Re: Notice of Disapproval Semiannual Progress Report on Chromium Plume Control Interim Measure Performance, July through December 2020 Los Alamos National Laboratory EPA ID#NM0890010515 HWB-LANL-21-019

# NMED DISAPPROVAL COMMENTS ON THE SEMIANNUAL PROGRESS REPORT ON CHROMIUM PLUME CONTROL INTERIM MEASURE PERFORMANCE, JULY THROUGH DECEMBER 2020, MARCH 2021 LOS ALAMOS NATIONAL LABORATORY, EPA ID #NM0890010515 LANL-21-019

# Chromium Concentrations at Regional Aquifer Monitoring Well R-45

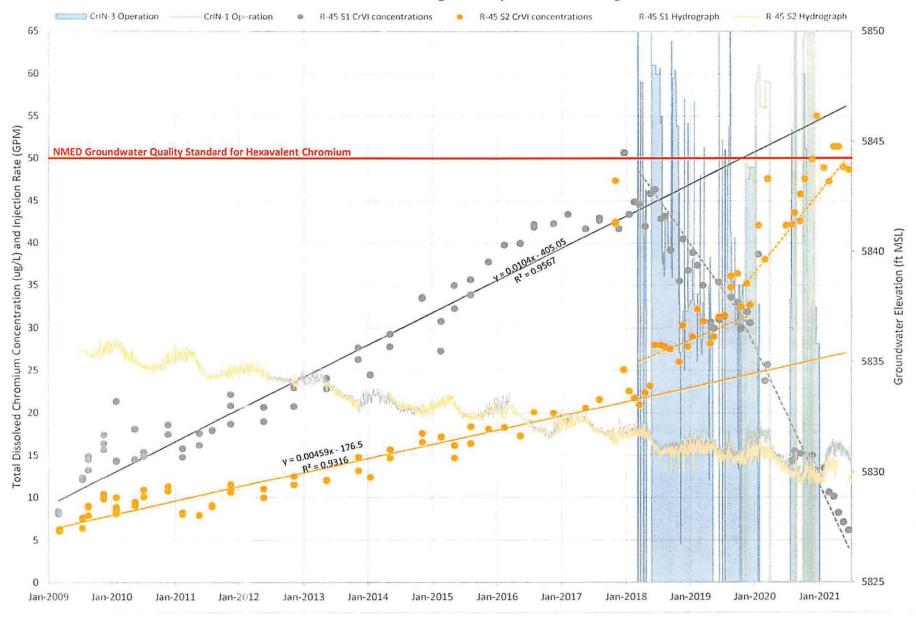
The "two working hypotheses" DOE provided in the Report to explain these responses are unsupported by hydraulic and chemical data. The plot in the Attachment shows a very high goodness of fit in the Excelgenerated coefficient of determination R-squared value for the chromium detections measured in R-45 S2 in over 10 years of monitoring before IM began. This trendline represents the natural increase in the chromium concentration and, if extrapolated into the future, the chromium concentration should not have reached a concentration of 50  $\mu$ g/L until February 2035, not December 2020. This contrasts with DOE's first hypothesis that it is the result of an upgradient preferential pathway unless DOE can substantiate that a new release of chromium has occurred. The second hypothesis is also unsupported because there are no significant vertical hydraulic gradients in this portion of the regional aquifer as shown by the hydrographs in the Attachment, and infiltration to the regional aquifer at this location has no substantial source to be a factor in the downward movement of the chromium at R-45 (see Specific Comment No. 9).

**DOE Statement:** "Although the chromium concentrations in R-45 S1 had begun to drop before IM operations began in the eastern area, injection may have already increased the rate of decline in chromium concentrations. *R-45 S2 did not show similar responses for the same period; chromium concentrations in this well screen have continued to increase. The increase in chromium concentrations predates eastern area IM operations (CrIN-1, CrIN-2, and CrEX-5) and is therefore likely unrelated to IM operations. Two working hypotheses for the presence of the deeper contamination in the R-45 and R-70 areas are being evaluated. One hypothesis is that the concentrations of chromium and related constituents observed in R-45 S2 reflect a deeper pathway that may originate further upgradient in the plume, possibly as far upgradient as the CrEX-4 area where a very similar geochemical signature is observed. Under that case, the increase in chromium in R-45 S2 simply represents plume variability. Other wells have historically shown similar patterns. A second hypothesis is that localized downward gradients caused by infiltration of young post-Cr-release effluent at locations further downgradient from locations where chromium originally infiltrated are at least partially responsible for the observed trend in R-45 S2."*  NMED Comment: The data illustrated in the plot in the Attachment show that the decrease in the chromium concentrations at R-45 S1 correlate exactly with the startup of injection wells CrIN-3, CrIN-4, and CrIN-5 in May 2018 and was later accelerated by the startup of injection wells CrIN-1 and CrIN-2 in November 2019. Conversely, these data also show two distinct and pronounced increases in the chromium concentration at the deeper R-45 S2 that also correlate exactly with the commencement of both IM injection operations. Consequently, DOE's assertion that the chromium concentration in R-45 began to decrease before IM operations began appears to be incorrect. In that statement, DOE only considers the eastern area IM, not the south area IM, which is the obvious cause of the first response shown in the Attachment. In the revision, DOE must provide a less biased discussion on this topic to include the southern area IM injection operations as the cause of the chromium responses observed at R-45 and to delete the "two working hypotheses" from the Report based on the following.
